Subject: Crystal River Unit 3
Docket No. 50-302
Operating License No. DPR-72

Enclosed are three (3) originals and forty (40) copies of Technical Specification Change Request Nos. 50 and 51, requesting amendment to Appendix A of Operating License No. DPR-72. As part of this request, proposed replacement pages for Appendix A are enclosed.

Technical Specification Change Request No. 50 [Appendix A]

Technical Specification Change Request No. 51 (Appendix A)

FIGURE 6.2-2 FACILITY ORGANIZATION

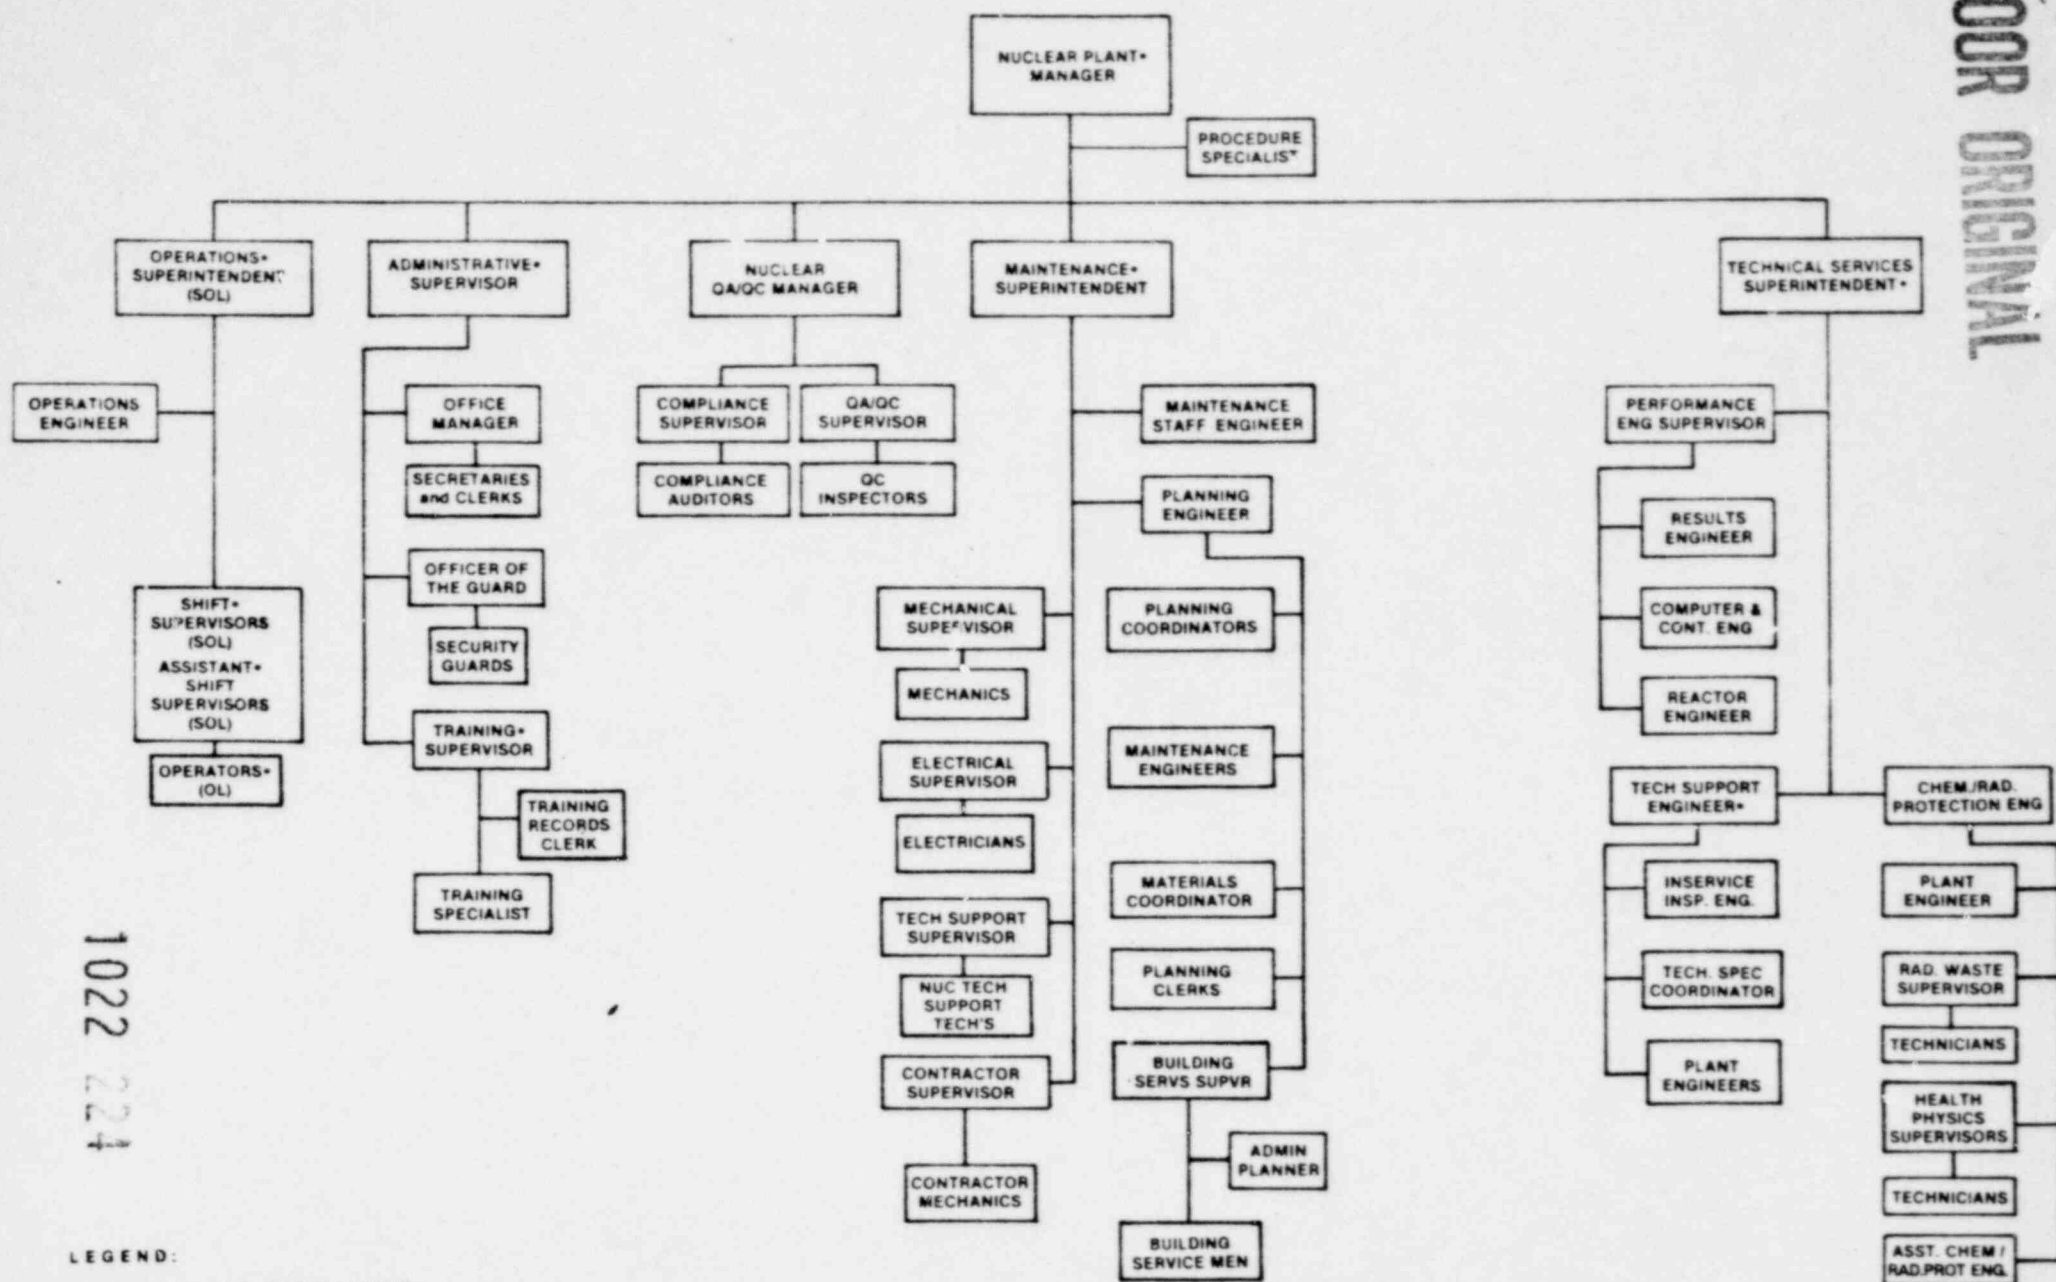
Replace page 6-3 with the revised page 6-3.

Realignment of the QA/QC group at Crystal River Unit 3. This organizational change consolidates the Compliance Section and the QC Inspectors under a new position, Nuclear QA/QC Manager, which reports directly to the Nuclear Plant Manager.

On March 23, 1979, Florida Power Corporation met with NRC Region II personnel in Atlanta to discuss their concerns about the effectiveness of our operational quality assurance program and management control system. As a result of this meeting and the QA/QC Audit performed by Region II, Florida Power Corporation, in our response of June 15, 1979, identified the attached organizational restructure as an essential element in developing an upgraded Quality Control Program at CR#3. This realignment is necessary to create a higher degree of independence for the QA/QC function, as well as to more clearly define the responsibilities of the QA/QC organization at CR#3.
